Freescale Semiconductor Reference Manual Errata

MCF5213RMAD Rev. 5, 11/2011

MCF5213 Reference Manual Errata

Supported Devices: MCF5211, MCF5212, MCF5213

Table 1. MCF5213RMAD Reference Manual Rev 5 Errata

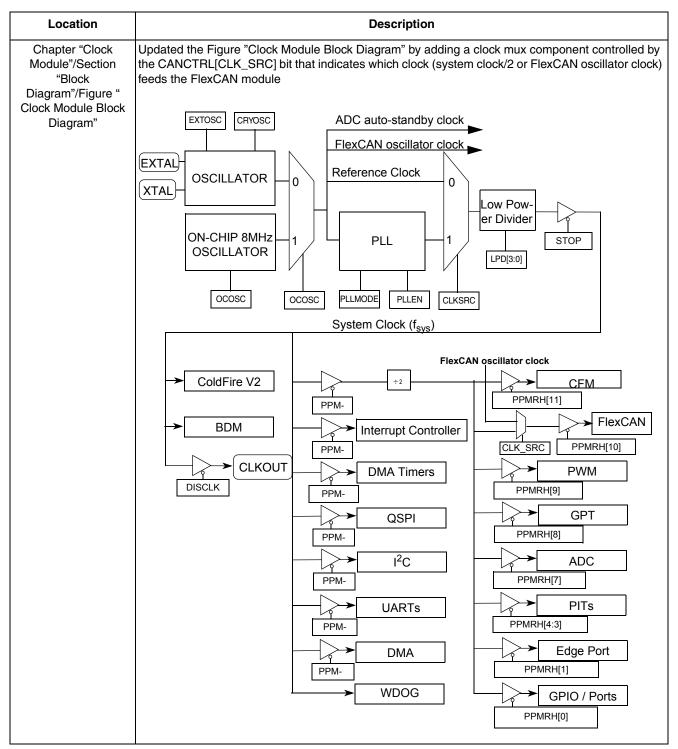
Location	Description
Chapter "FlexCAN" Section "FlexCAN Control Register (CANCTRL)" /Table "CANCTRL Field Descriptions"	Change from: $S \ clock \ frequency = \frac{f_{SVS} \ or \ EXTAL}{PRESDIV + 1}$ Change to: $S \ clock \ frequency = \frac{f_{SVS/2} \ or \ FlexCAN \ oscillator \ clock}{PRESDIV + 1}$
Chapter "FlexCAN" Section "FlexCAN Control Register (CANCTRL)" /Table "CANCTRL Field Descriptions"	In the Description of field 13 CLK_SRC bit Change from: 0 Clock source is EXTAL 1 Clock source is the internal bus clock, fsys Change to: 0 Clock source is FlexCAN oscillator clock 1 Clock source is the internal bus clock, fsys/2
Chapter "FlexCAN" /Section "Protocol Timing"/Figure "CAN Engine Clocking Scheme"	Change from: $f_{Tq}=\frac{f_{\rm sys}~{\rm or}~{\rm EXTAL}}{({\rm PRESDIV}+1)}$ Change to: $f_{Tq}=\frac{f_{\rm sys/2}~{\rm or}~{\rm FlexCAN}~{\rm oscillator}~{\rm clock}}{{\rm PRESDIV}+1}$
